CLARIFICATION RESPONSE NO. 1

WASHINGTON STREET SIDEWALK AND LIGHTING IMPROVEMENTS

May 26, 2016

FIXTURE TYPE 'P'
POLE FOUNDATION DETAIL

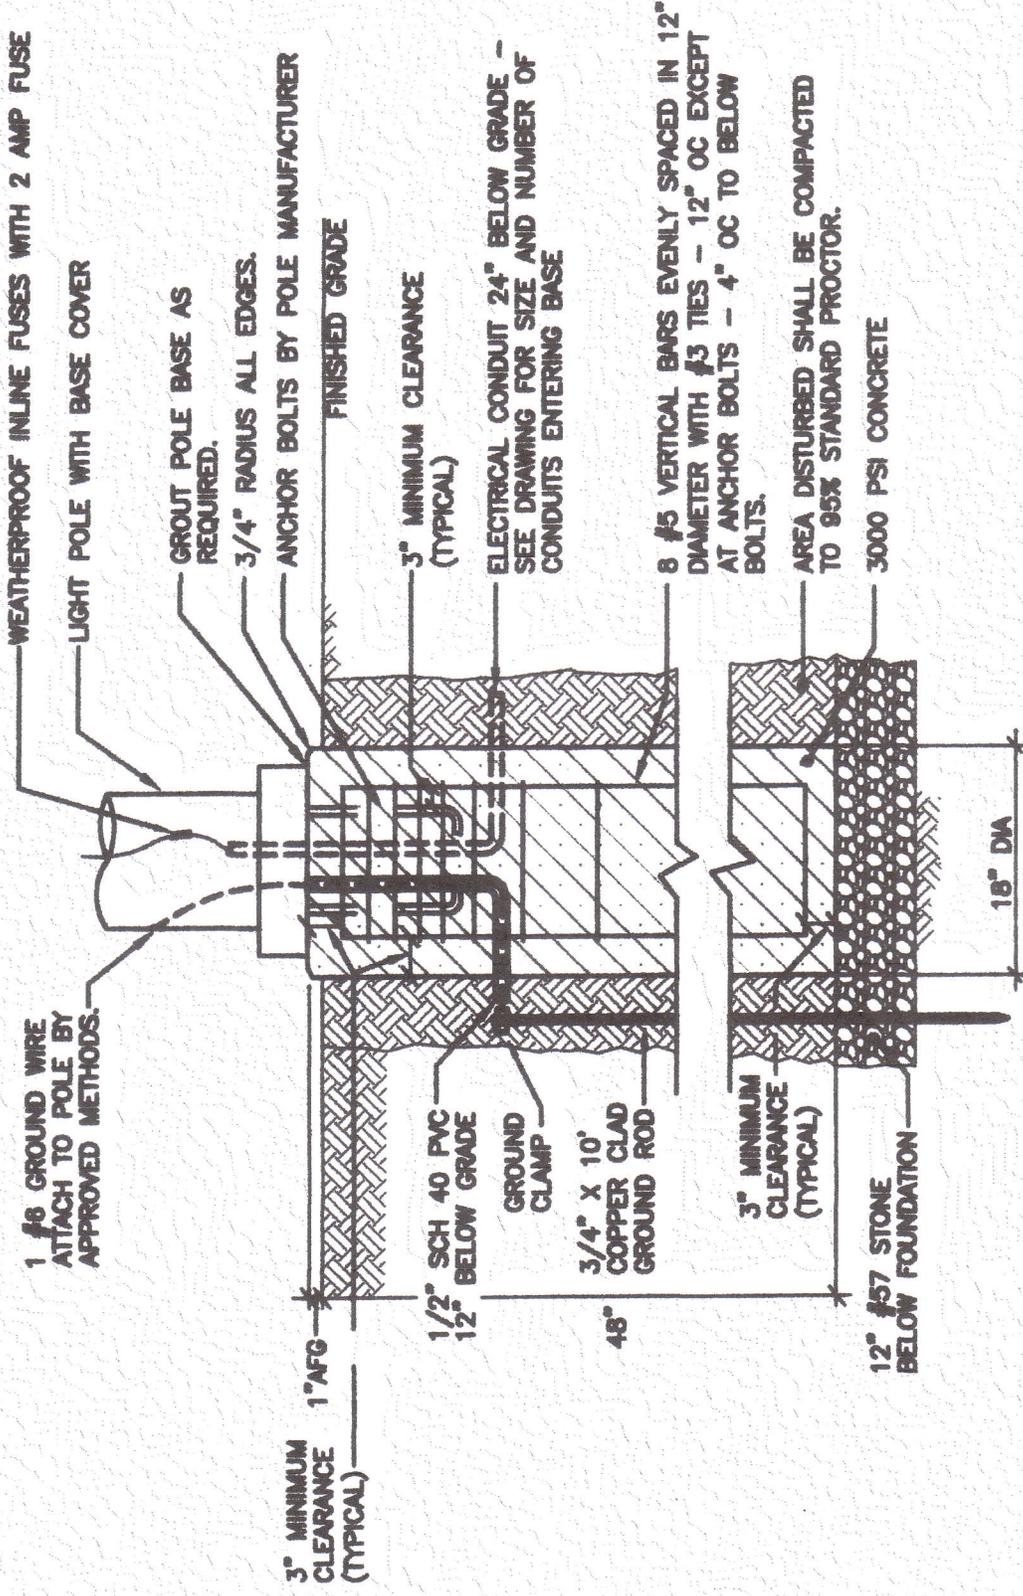
The light pole foundation detail shown on Drawing No. E2 indicates the required depth to be 72". This foundation detail is only required for the light pole and foundation replacement on Commerce Street at Macon Road as shown on Drawing No. C1 in the General Layout.

Light pole foundations installed along Washington Street as shown on Drawing No. E2 shall have a depth of 48". Please refer to the attached "Fixture Type 'P' Pole Foundation Detail".
